Appeal NO: ABP 318180

Observations of Colin Doyle 14<sup>th</sup> July 2025 on Applicant's Response 318180

**Universal Developers LLC data centre at Cruiserath Road, Dublin 15**

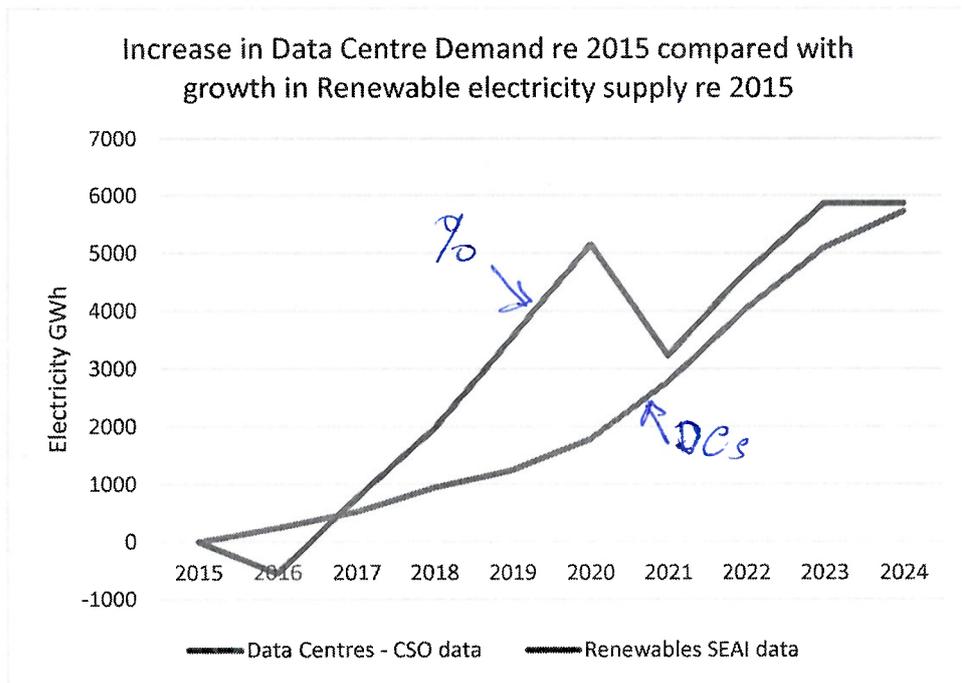
"Electricity supply from renewables grew by 1.3% in 2024 but, due to increased demand, the share in renewable energy generation decreased slightly from 40.7% in 2023 to 39.6% in 2024. "
32. Based on data from the SEAI National Energy Balance published in 2025<sup>5</sup> and CSO metered data centre energy consumption, it can be seen from the graph further down that growth in renewable electricity energy supply since 2015 has been almost equally matched by the growth in data centre energy consumption. This has resulted

in the percentage of renewable electricity on the grid stalling at around 40% for the past four years, as shown in the table below.
